Program Plan Coordination Meeting
October 17, 2019

Discussion Topics Requested by EPA

Figure 8.2-1: CSO Volume Capture by Catchment under the Baseline Level of Control

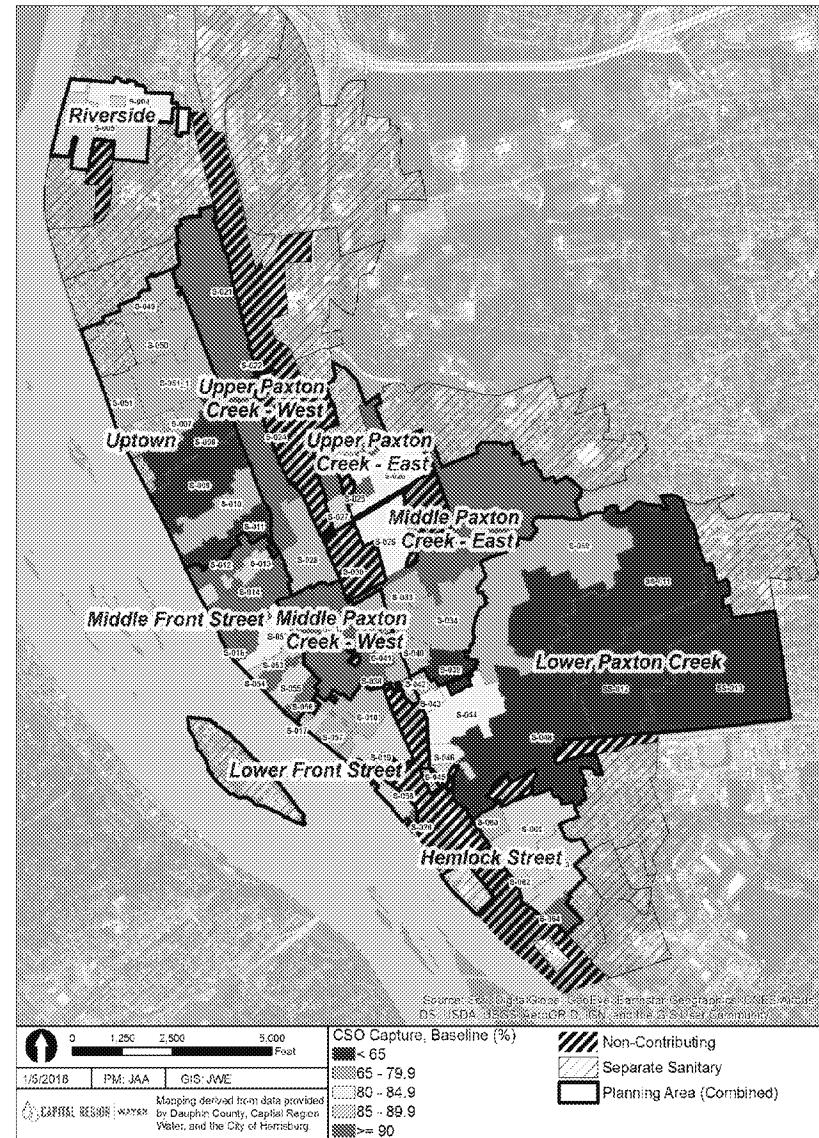
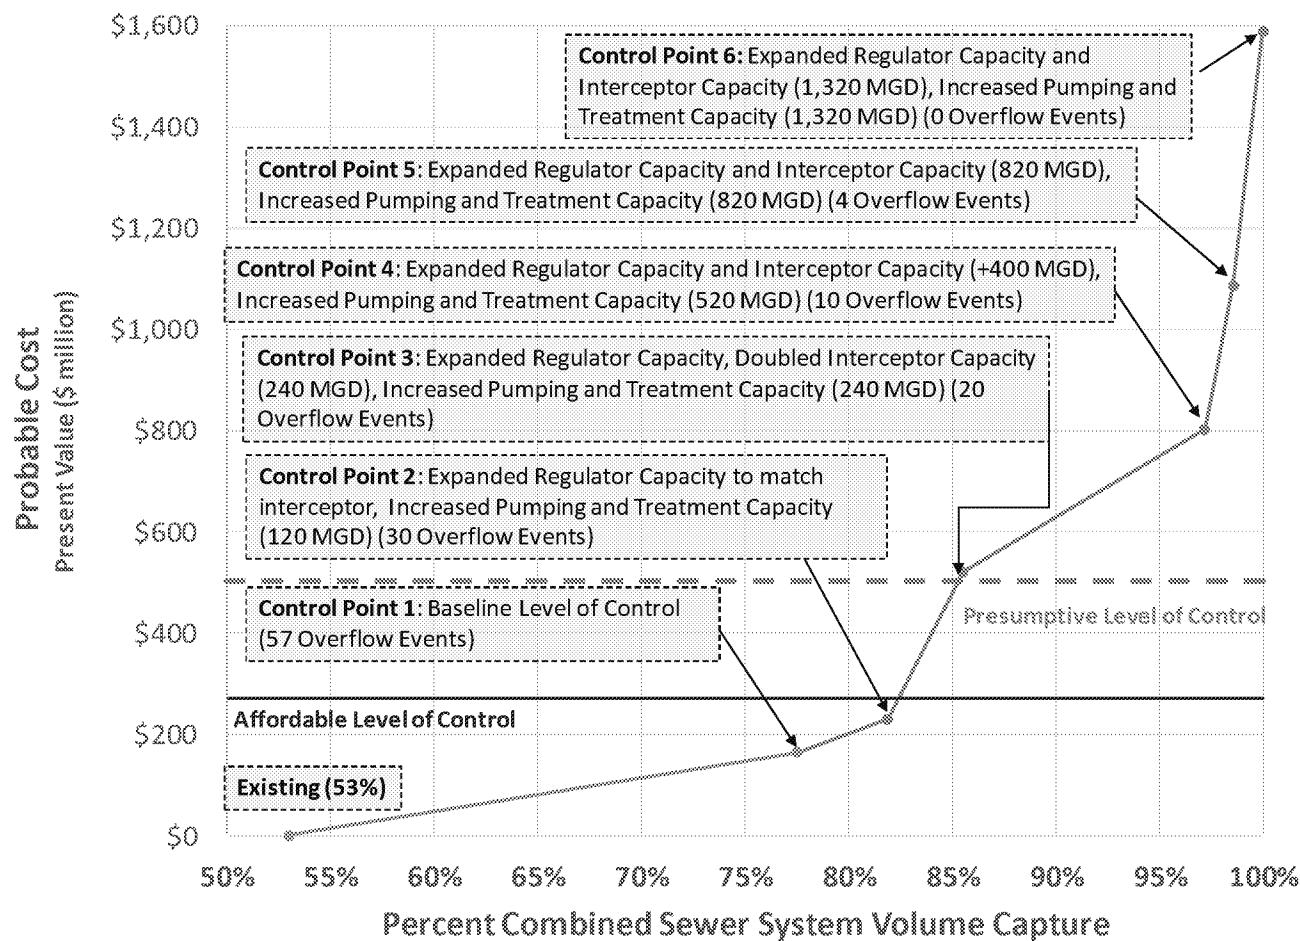
EPA Discussion Point. *"It is critical that CRW plan ahead based on the actual hydraulics needs of its wastewater collection and treatment system when doing remedial work. Otherwise, implementation of supplemental CSO controls may cost more in the future. The current LTCP seems to reflect a relatively narrow view of alternative analysis that does not appear to maximize cost effectiveness since it does not consider the full gambit of alternatives that could be applied individually to each combined sewer basin".*

CRW Response. The Section 8 alternatives analysis evaluated the full range of alternatives, building upon the hydraulic capacities of the CRW interceptors, pump stations, and AWTF.

- Cost is \$181 million in 2017 dollars and would be implemented over 8 to 10 years
 - Makes the CRW system reliable and resilient and maximizes initial wet weather control
 - Includes priority remedial repairs to the AWTF, the interceptor system, and the collection system
 - Increases hydraulic capacity of the AWTF, interceptors and pump stations to 80 MGD
 - Modernizes CSO regulators to increase wet weather capture and reduce river intrusion.
 - Addresses priority needs identified by the CCTV investigations within the collection system
- CSO capture would increase (from 53% to 78%), CSO frequency would be reduced (from 12 to 95 to a range from 0 to 57) CSO duration would decrease (from 700 to 225 hours/year)
- The backlog of deferred maintenance would be caught-up and a proactive O&M program would begin

Program Plan Section 8.4.5: Lower Front Street Planning Area

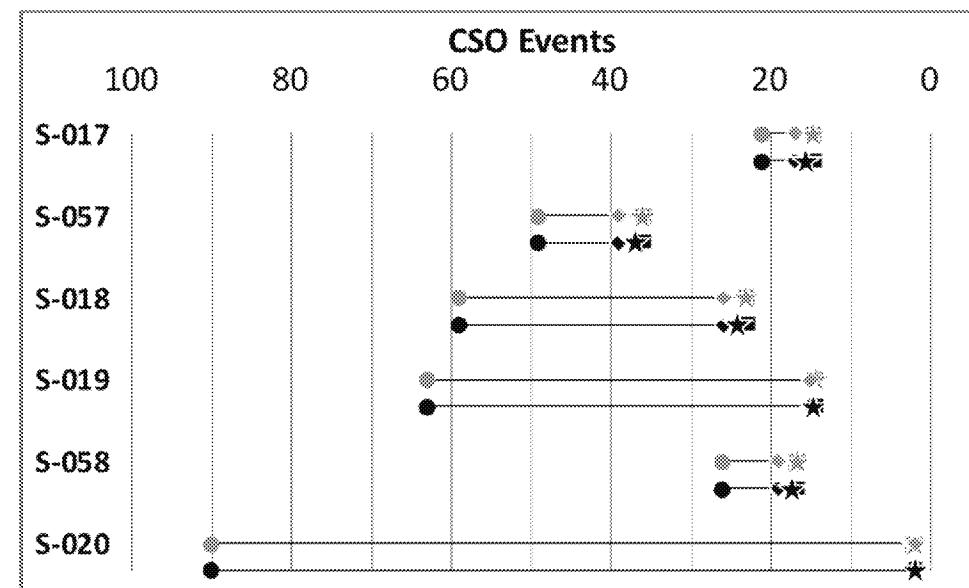
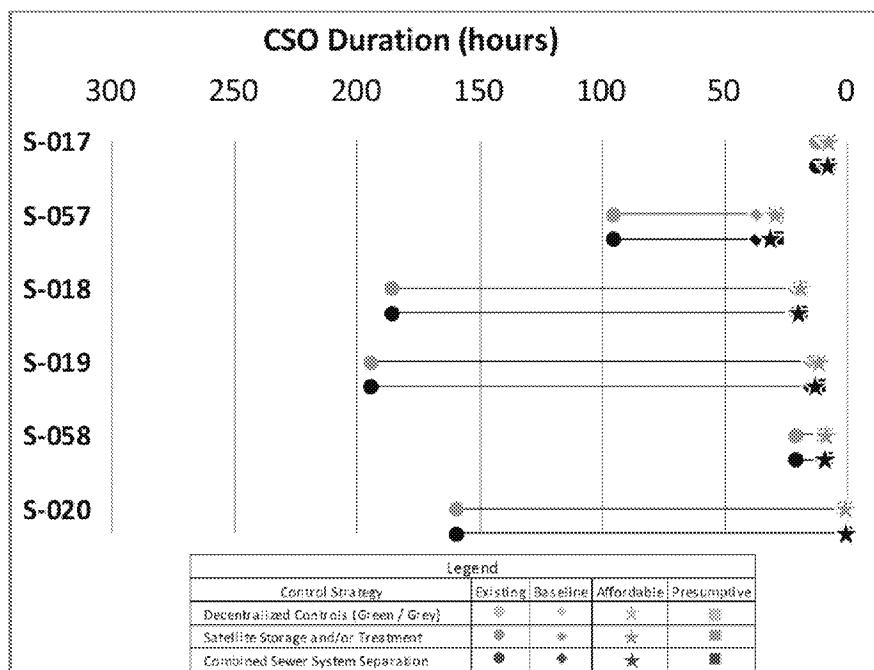
EPA Discussion Point. *"Evaluate the cost of life cycle of GI alternatives and the expected reductions in volume and frequency of CSOs."*

Existing and controlled CSO discharge frequency and duration values are also provided for each outfall

Existing and controlled condition CSO discharge durations tend to be short and flashy

Figure 3-21: Interceptor and Suburban Community Point of Connection Monitoring Sites

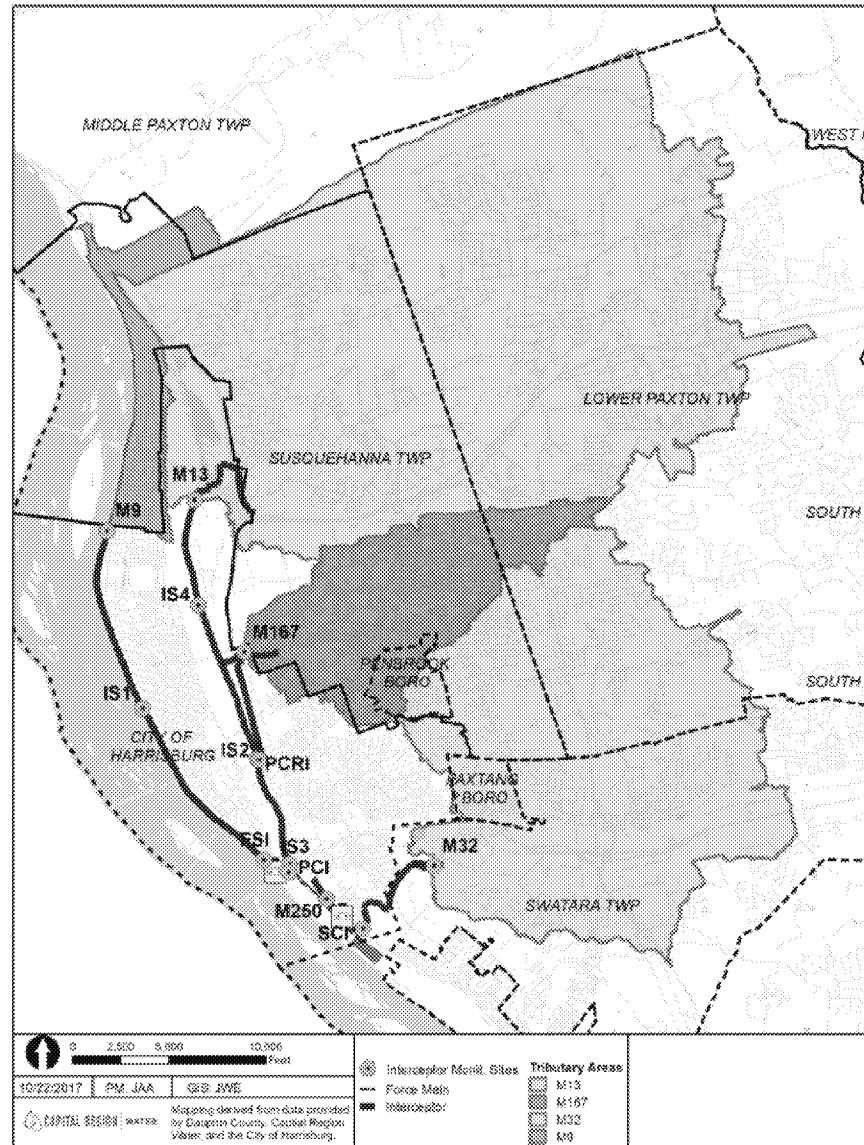
EPA Discussion Point. *"Reduction of satellite community wet-weather I/I: While satellite I/I reduction is not a specific combined sewer area improvement, for every gallon of wet-weather of separate sewer I/I that can be eliminated, an additional gallon of combined wastewater can be captured. Implement initial level sensing in key separate sewers to track wet-weather I/I impacts from satellite communities."*

- All of the major points of connection from suburban community systems are continuously monitored
- The RDII components of the flow have been fully analyzed
- Relative “leakiness” of these collections systems is relatively low, and flow reduction potential may be low

60% of CSO
Regulator
Orifice
Openings

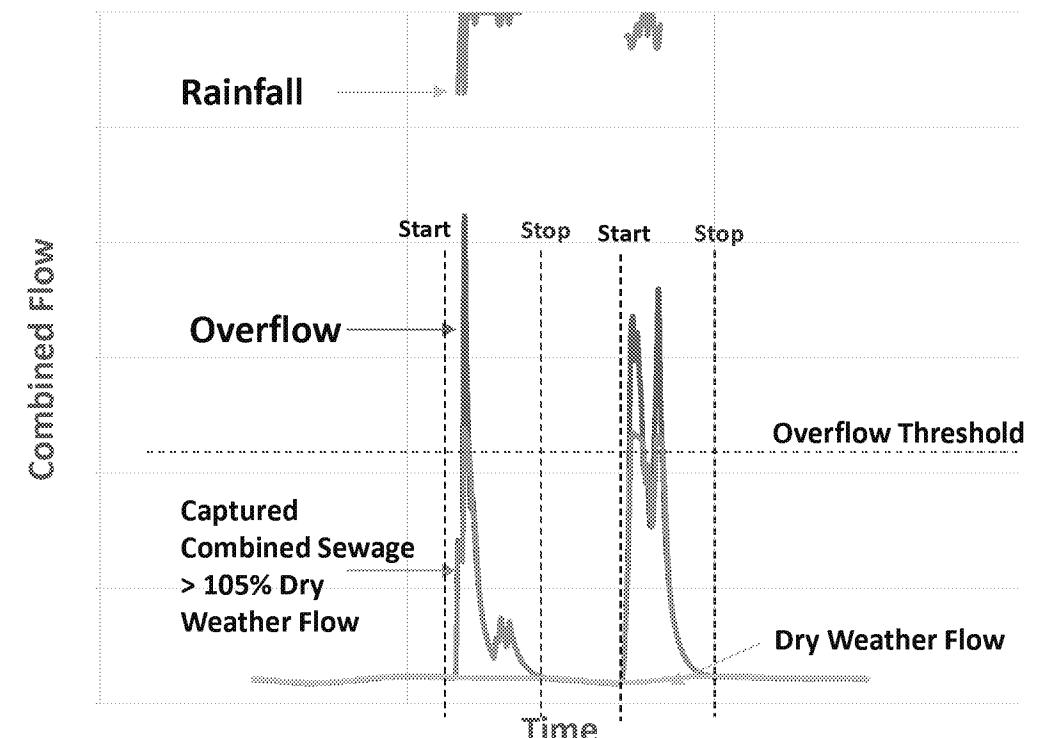
EPA Discussion Point. *"Properly calculate CSO capture percentage. The unusually high CSO frequencies remaining after supposedly achieving 80+ percent capture in the CRW combined system suggest inherent errors in CRW's combined flow capture calculation formula/process. Also, please note that the 85% minimum capture requirement in the 1994 CSO Policy is NOT a finite compliance criterion. The cost-benefit analysis process should still be considered as presented in the CSO Policy to determine the required compliance criterion, whether measured by number of overflow events or percent capture. The compliance capture percentage and event frequency are the products of cost-benefit analysis, not final criteria."*

- Small CSO catchments: CRW system size is similar to Lancaster but 12X as many regulators and outfalls, leading to short times of concentration, high peaks, and minimal flow attenuation/storage
- In existing conditions, Brown & Brown regulators and small orifice plates limit capture of small intense events
- In planned Baseline Condition, more flow reaches the interceptor after regulator improvements but many CSO regulators are close to the crown of the interceptor so when interceptor reaches capacity CSOs are activated because of backflow prevention devices activating
- The periods are often brief (<2 hours) as the peak works its way through the system and volumes are small because of the small catchments
